CALIFORNIA COASTAL COMMISSION

Addendum

Subject: Addendum to **Item F 9b**, Coastal Commission Permit Application
#A-6-CII-08-028 (Moss), for the Commission Meeting of August 8, 2008.

Figure No. VII
Job No. 07-9342

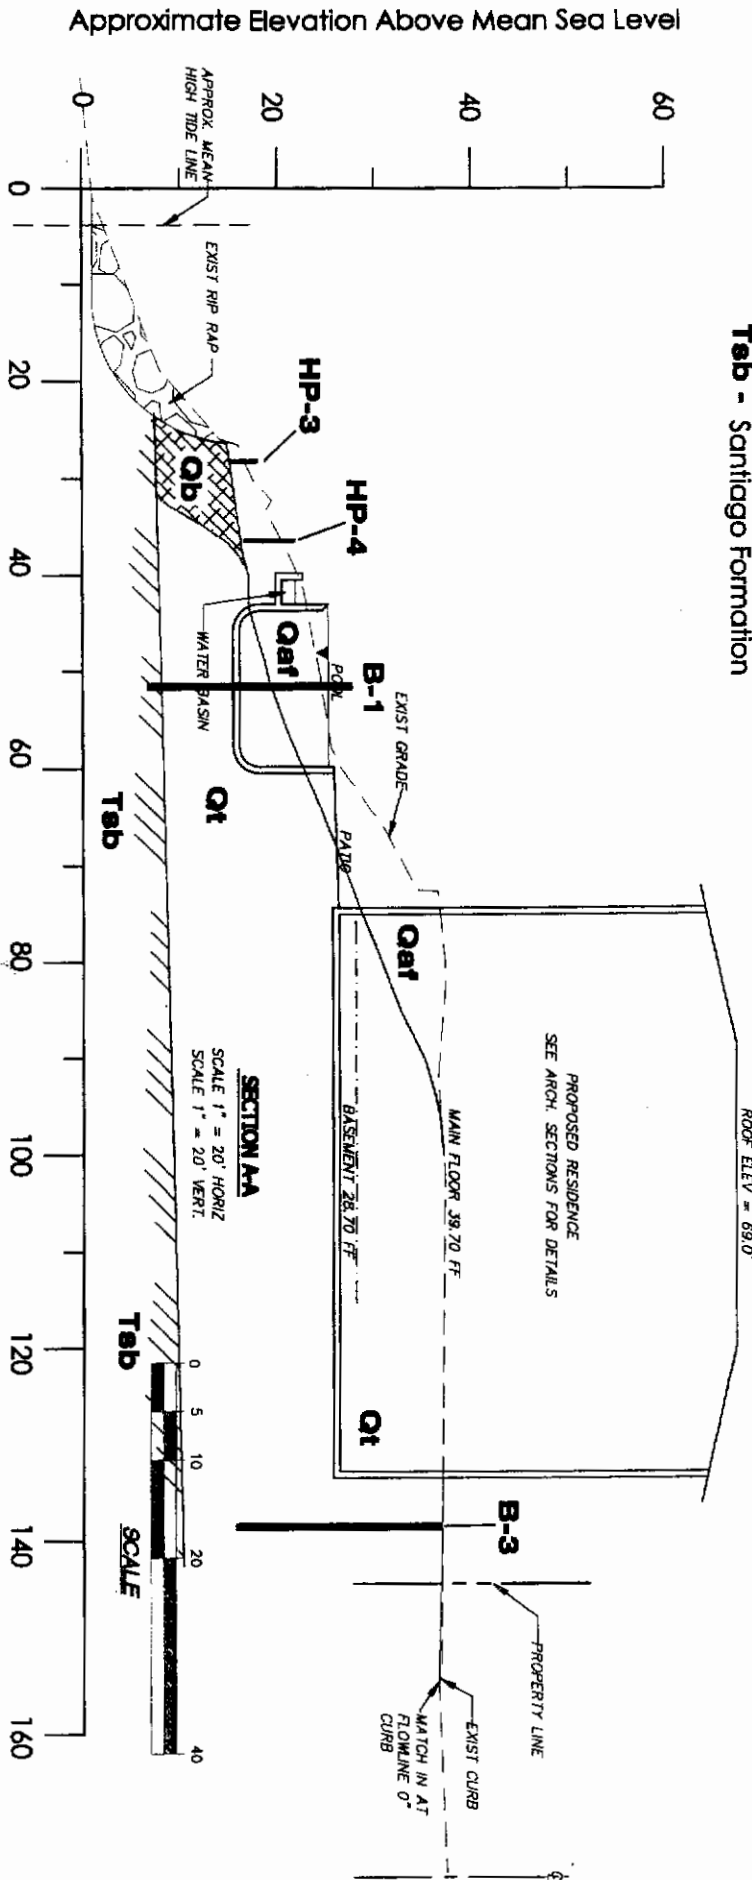
Thank you for allowing me to provide supporting information as to the variables in the sand fund calculation. I believe that 2 of the variables for Lesley's calculation are incorrect. These variables are the width of the structure (revetment) E and the "difficult to measure" v.

1. Attached please find a blow up of the geologic cross section (Moss-width.pdf). It should be noted that the actual width is arguably 10 feet but clearly no wider than 11 feet. The additional 4 feet added by coastal was actually the extension of the structure slope line or envelope NOT actual encroachment or use of beach. Rocks are not like sand they have a vertical dimension, in this case ~ 3 feet. You can count the little squares, they are 1 foot intervals.

Aerial Comparison of 20' Contour vs. 36' Contour

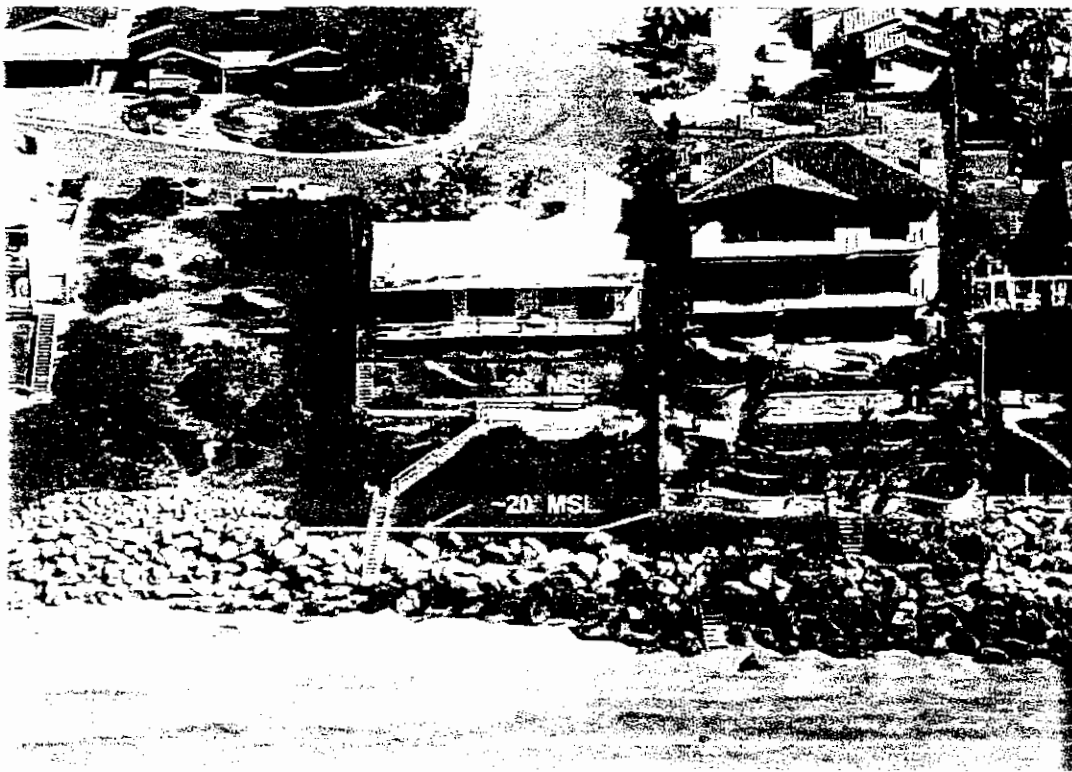
We ask that you remove Special Condition #1, which would allow the City-approved 20' contour to be applied as the bluff edge for purposes of establishing development limits and would allow the entire stairway to be retained in its current configuration. The project should be approved as proposed for the following reasons:

The Commission recognizes that there is a break in the lower slope on the bluff face (approximately 20’ MSL contour). However, as defined above, the top of the bluff is located at the 36’ MSL contour. The applicant’s consultant argues that the bluff edge corresponds with the 20’ MSL contour because that is the point where a well defined break in slope occurs and the inclination of the more gently sloping marine terrace deposits increases significantly down to the beach. However, as noted above, the Commission’s staff geologist has reviewed the technical reports prepared for the project and indicates that the material in which the bluff is cut has no bearing on the bluff edge determination based on the definition cited above. In other words, a break between the marine terrace deposits and bedrock does not define the bluff edge. Bluffs may be cut in a variety of materials; bedrock, marine terrace, non-marine deposits, ancient sand dune, modern sand dunes; or into combinations of these. However, these cuts or breaks do not necessarily define the edge of bluff. Therefore, using the above-cited definition of bluff edge, the most accurate location of the bluff

edge is at the 36' MSL contour, as previously determined by the Commission on the adjoining property to the north (ref. Appeal A-6-CII-07-17).

EXHIBIT NO. 6
APPLICATION NO.
A-6-CII-08-028
Aerial Map of Tierra Del Oro
 California Coastal Commission

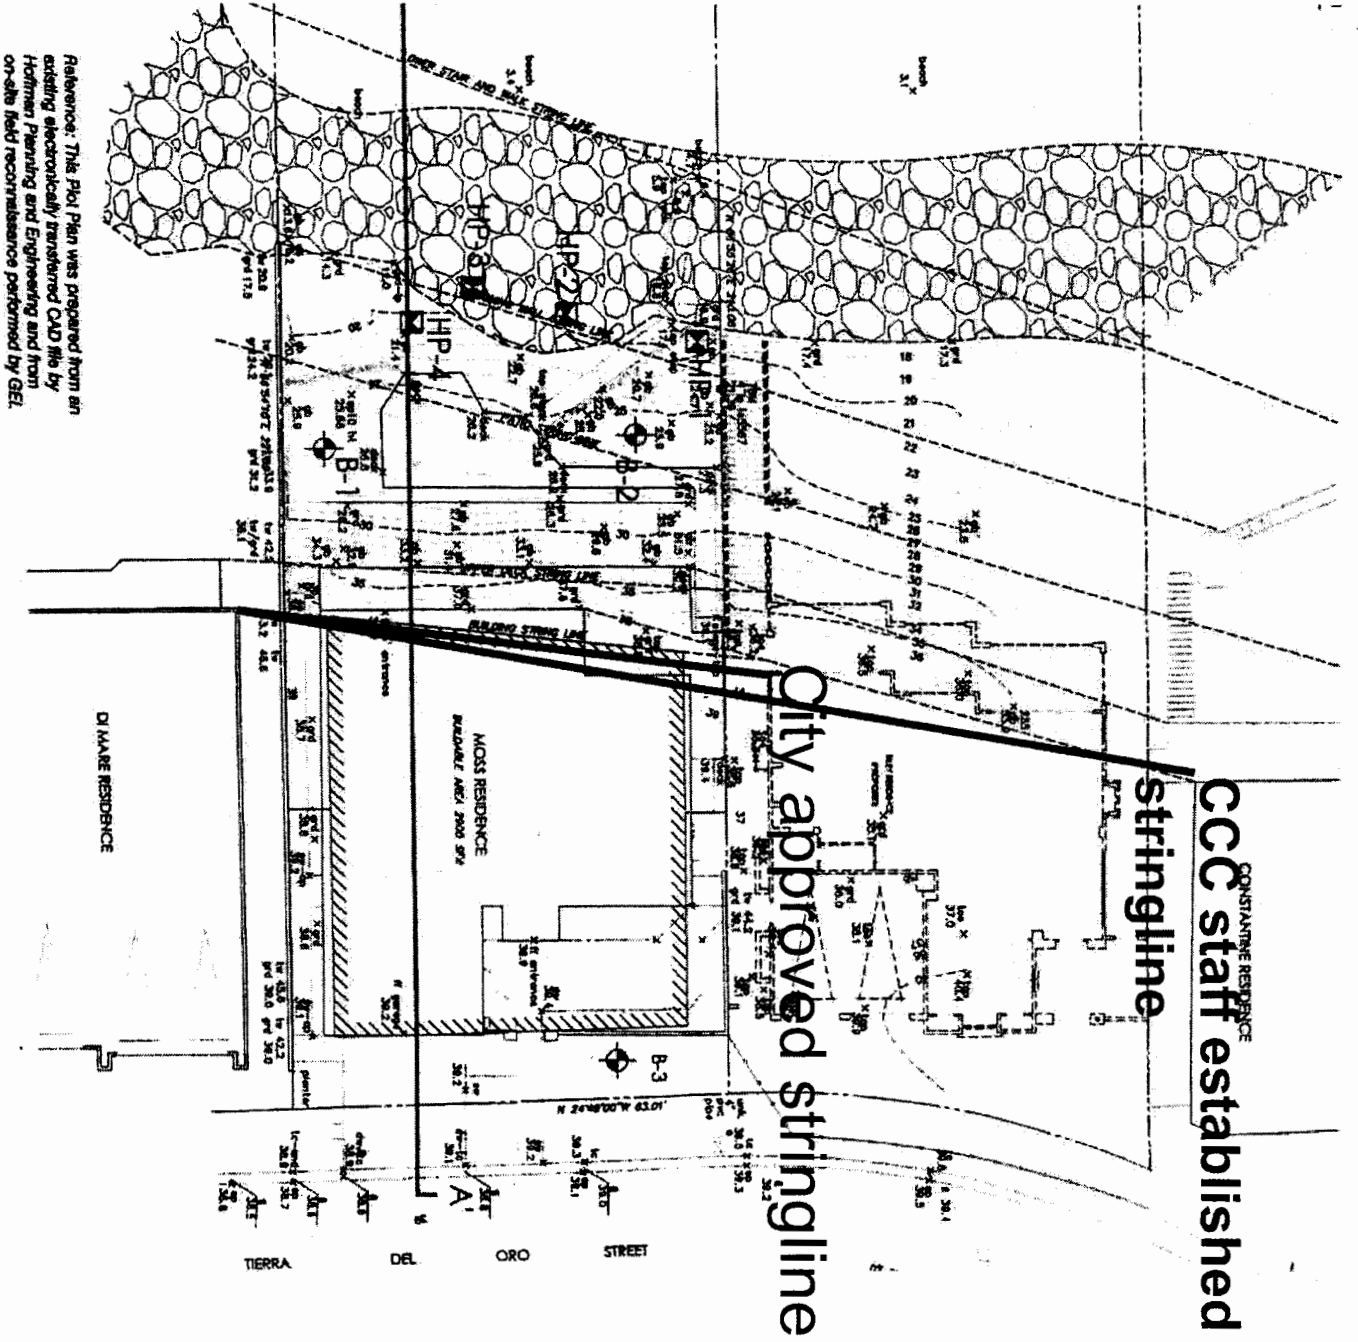
The Commission recognizes that development on the bluff face exists at several other locations on Tierra Del Oro (ref. Exhibit #6). However, most of these projects occurred before the Commission had a geologist on staff to advise it on the location of the bluff edge; now that the bluff edge has been defined at approximately +36' MSL and given the City's LCP provisions restricting development on the face of the bluff to only public accessways (private accessways are not permitted), these types of projects located beyond the established bluff edge (36' contour) can no longer be found consistent with the City of Carlsbad's certified LCP. For example, in 2004, the City approved a Coastal Development Permit for an addition and remodel of the residence located directly south of the applicant's residence (ref. 6-CII-04-160/Viola). This CDP did not include any improvements beyond the top of the bluff, and adhered to the appropriate stringline requirements; and as such, no appeal of the City's decision was filed by the Commission. In 2005, the City issued another administrative CDP for the adjoining site to the south, which was described on the Notice of Final Action (NOFA) as construction of a pool and spa within existing patio of single-family residence (ref. 6-CII-05-176/Viola). Because the project was approved administratively and because the project description did not include that the development was proposed on a bluff top lot, Commission staff did not identify the development as potentially inconsistent with the certified LCP and an appeal was not filed by the Commission. In reviewing aerial photographs of the surrounding neighborhood, it is apparent that the development on the property south of the subject site is actually out of character with the surrounding neighborhood and should not be used as the "model" by which other development in the area should be based on. As such, Special Condition #1 requires the applicant to submit revised final plans showing the deletion of any/all development proposed past the established 36' MSL contour bluff edge (i.e., the pool, spa, patios, retaining walls, etc.) that cannot be considered ephemeral and capable of being removed. Further, Special Condition #11 requires the applicant to submit, within 60 days of completion of construction, as built plans for the development showing that the development has been completed consistent with the final approved plans.
